DATE RECEIVED	6/6/94 <i>Intentional</i>	PERMIT NUMBER	ACT/015/018
Title of Proposal:	Sediment <del>Control</del> Box	PERMIT CHANGE #	94G
Description:	Denied 10/93 and 4/6/94 Now Resubmitted again	PERMITTEE	<i>Triflorop</i>
		MINE NAME	<i>Deer Mine</i>

Title: <u>Sediment Retention Box</u>	PERMIT NUMBER: <u>015/018 #3</u>
Description:	PERMIT CHANGE #: <u>94 G</u>
	MINE: <u>Deer Creek</u>
	PERMITTEE: <u>Pacificorp</u>

TO: Daron Haddock, Permit Supervisor  
FROM: Wayne H. Western, Reclamation Engineer *WHW*  
RE: Sediment Retention Box Amendment, PacifiCorp, Deer Creek Mine,  
ACT/015/018, Folder #2, Emery County, Utah

RE: SEDIMENT RETENTION BOX AMENDMENT, PACIFICORP, DEER CREEK MINE,  
ACT/015/018, EMERY COUNTY, UTAH

## Simplified Bishop Slope Stability Analysis

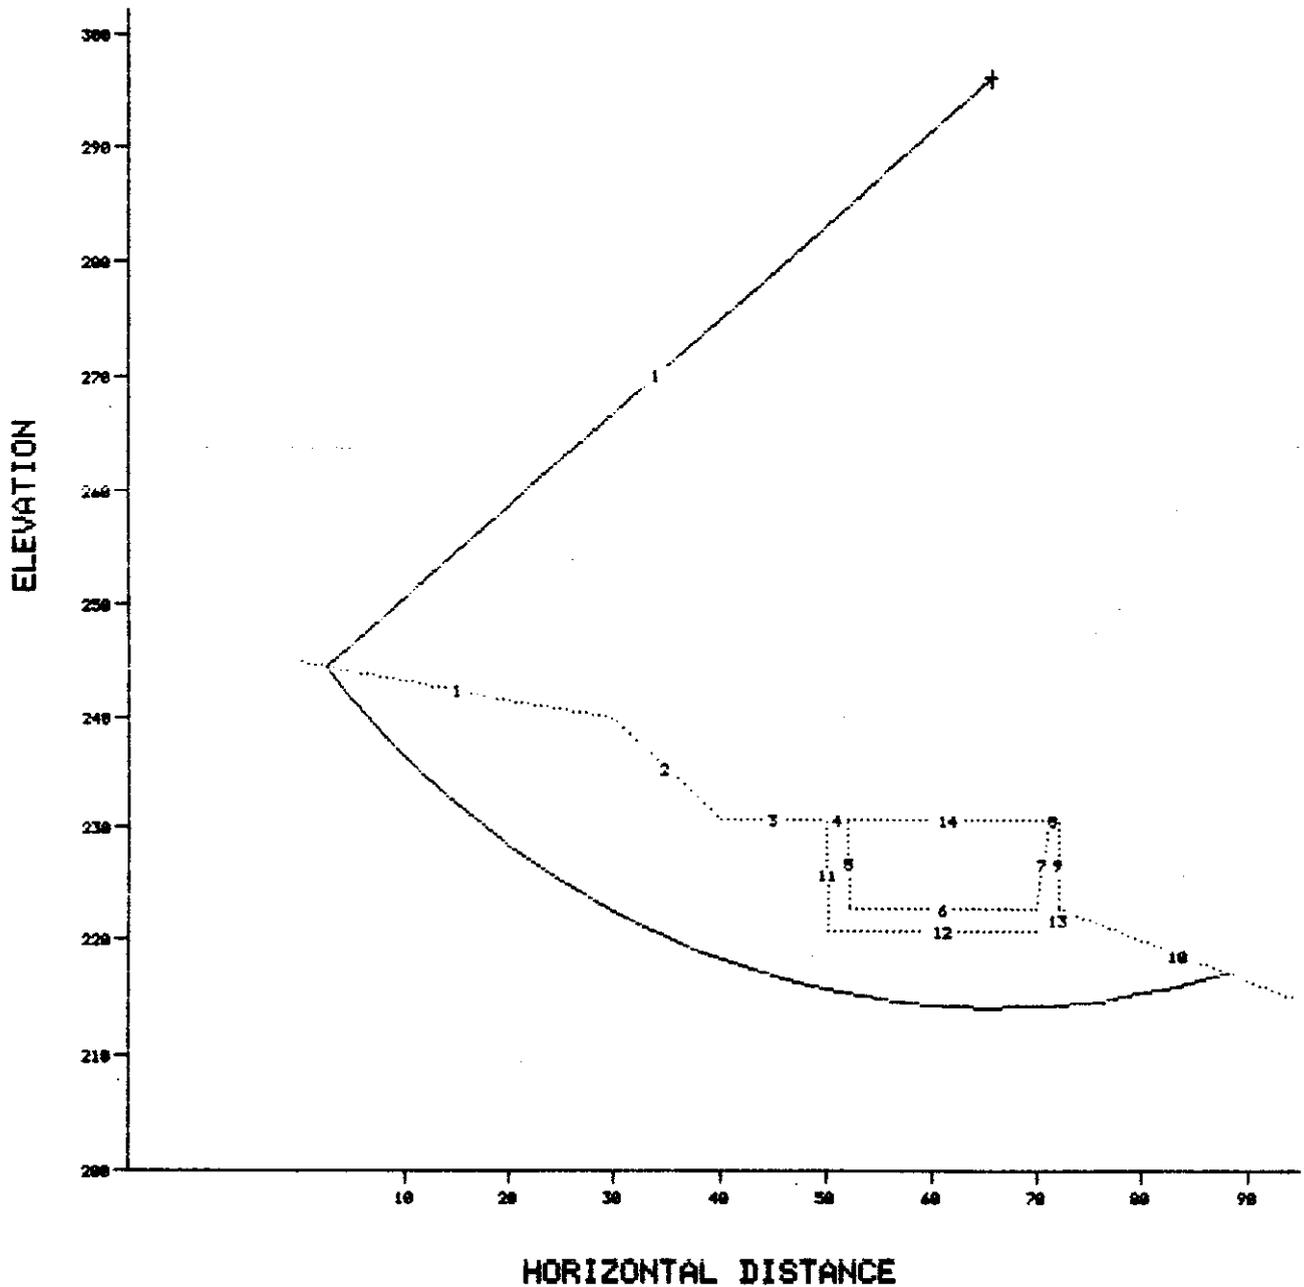
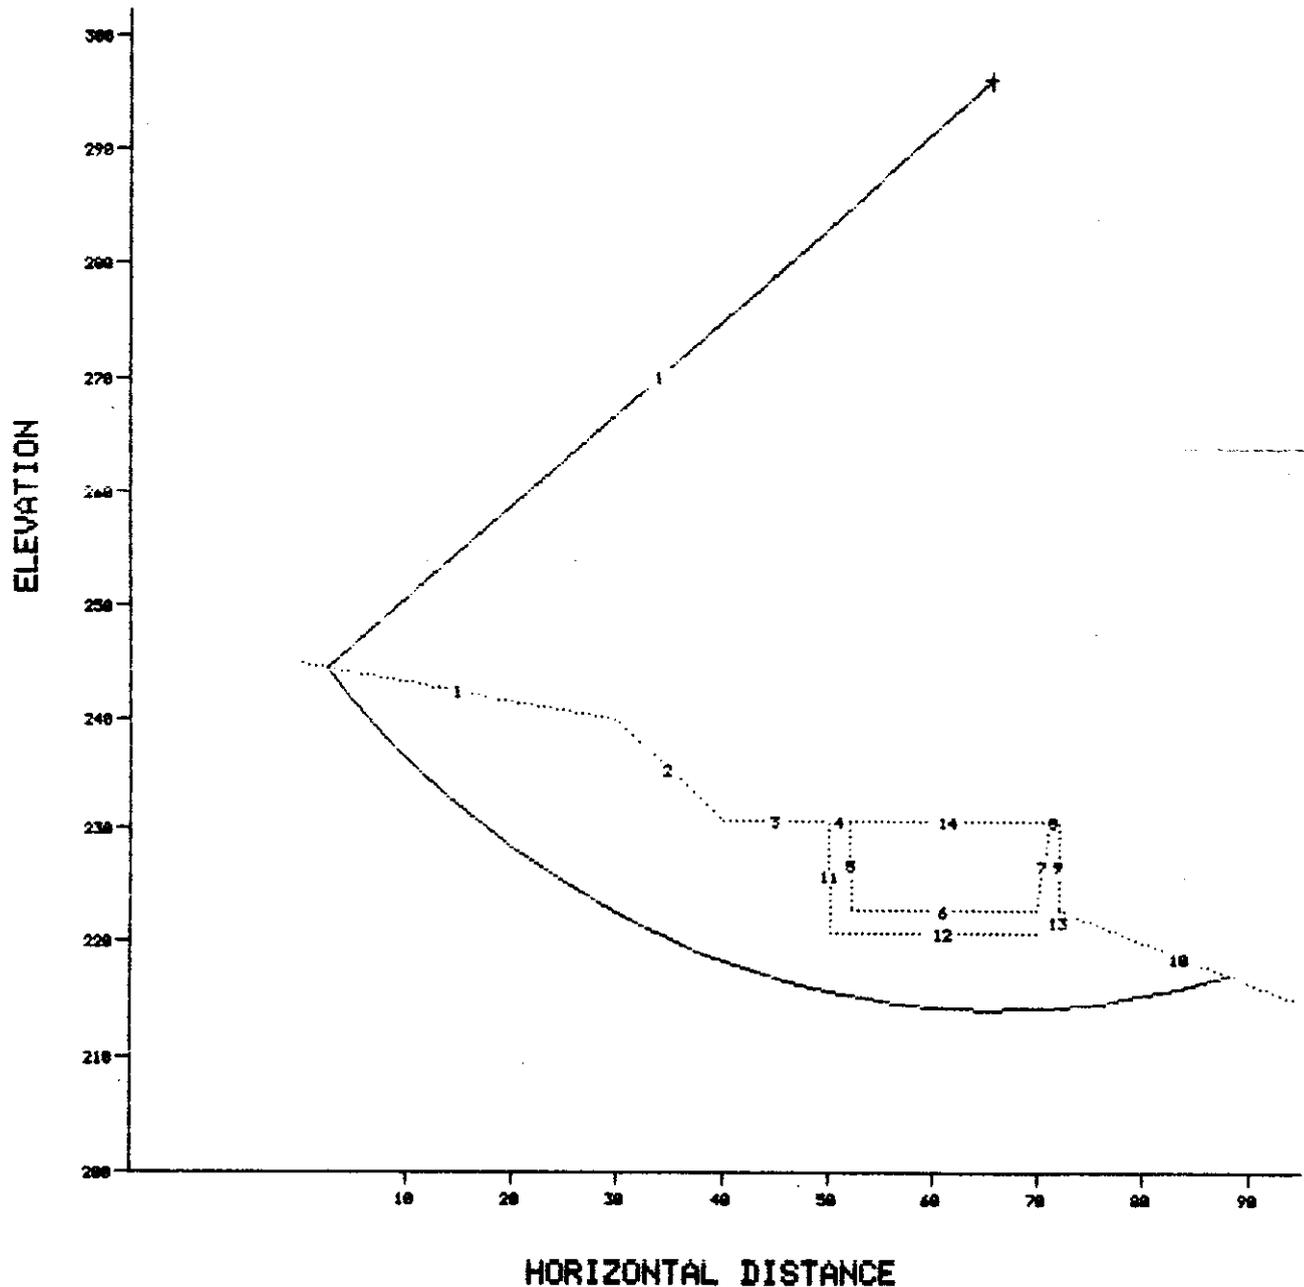
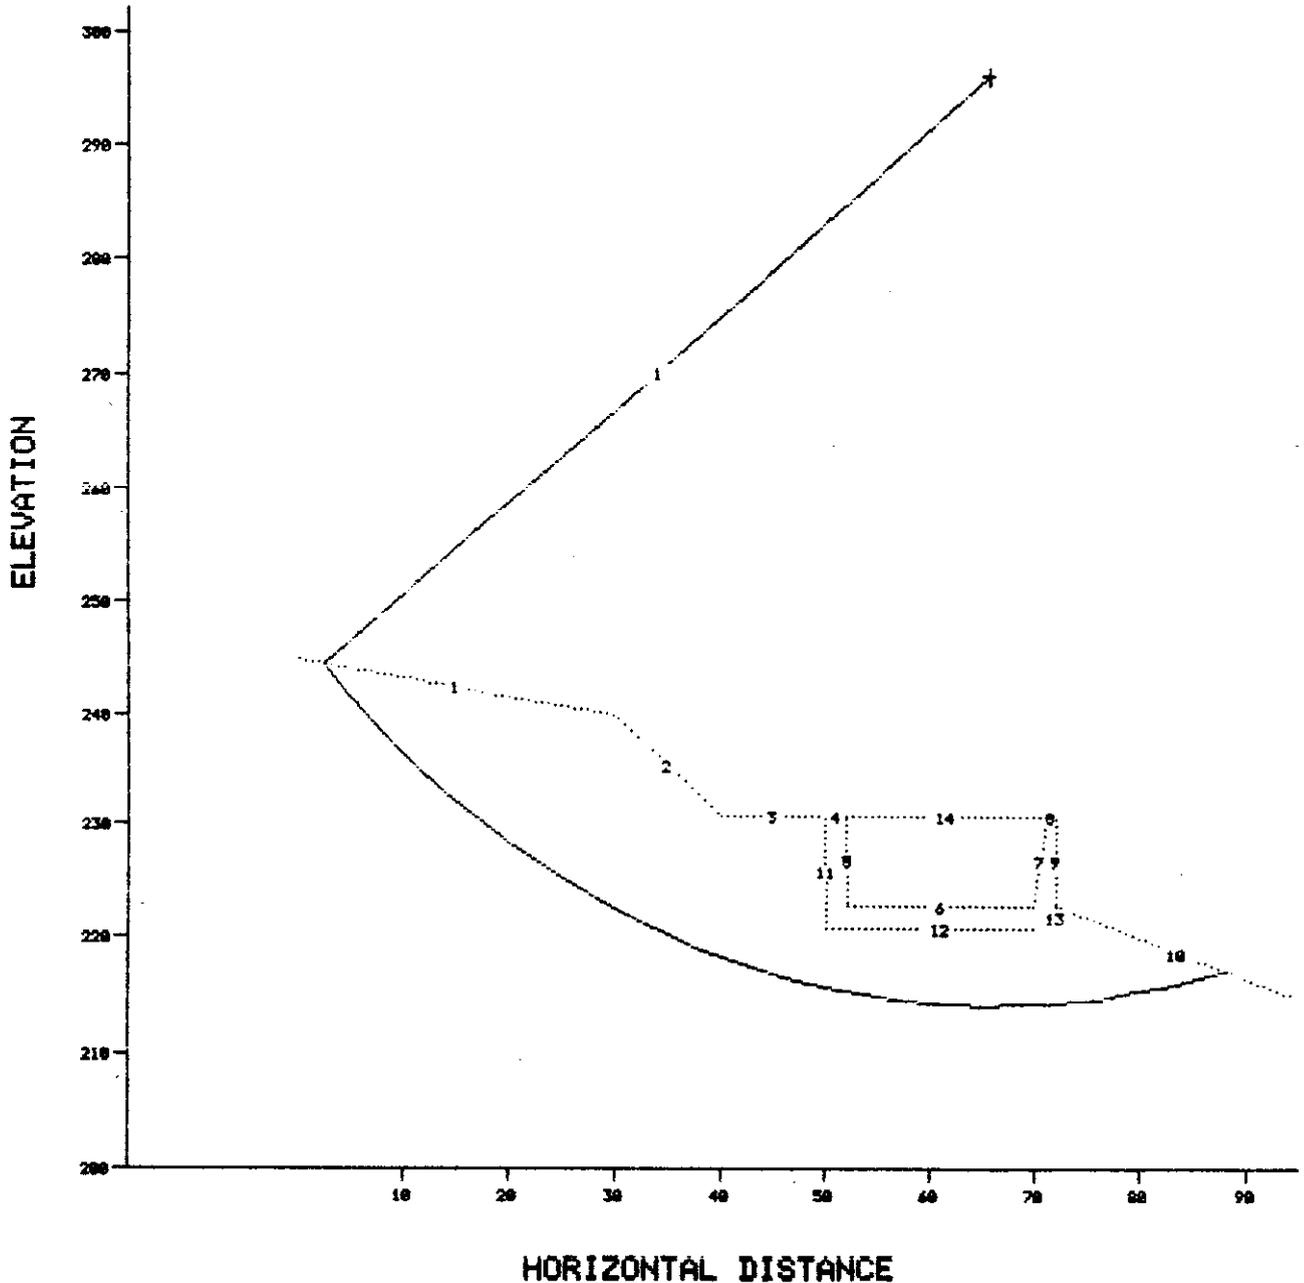
In the Division's letter of June 17, 1994, two deficiencies to the Operator's sediment retention box were stated. The deficiencies involved: (1) a stability analysis of the slope on which the box would be located, and (2) showing the access road to the pond on the surface facilities map.

The slope on which the sediment pond will be located must have a minimum static safety factor of 1.3. The Operator has submitted a stability analysis showing the slope has a safety factor of 7.04, which exceeded the regulatory requirement. The road to the retention box is shown on a surface facilities map. All of the deficiencies addressed in the June 17, 1994 letter have been met.

The slope stability analysis did not include the safety factor. The Operator also proposed placing three-foot diameter materials in eighteen-inch lifts. The Division has concerns that such large materials would decrease the slope's safety factor. The Operator needs to submit a detailed slope stability analysis that includes the slope's safety factor. A safety factor of at least 1.3 is required for the slope. The Operator's response is insufficient.

6/17  
 I did state the opposite and I stand by what I said. The assumption of this paragraph is, for stuff above gravel size, not correct.  
 Jek

The slope stability concern is addressed by replacing the 6/1/94 page 6.1 with pages 6.1 and 6.2 of this submittal. Drawing DS149D has been corrected to address the second deficiency. Please replace the drawing submitted on 6/1/94 with the enclosed drawing. A modification to the 6/1/94 The "Application for Permit Change, Detailed Schedule of Changes to the Permit", is submitted to reflect the changes.
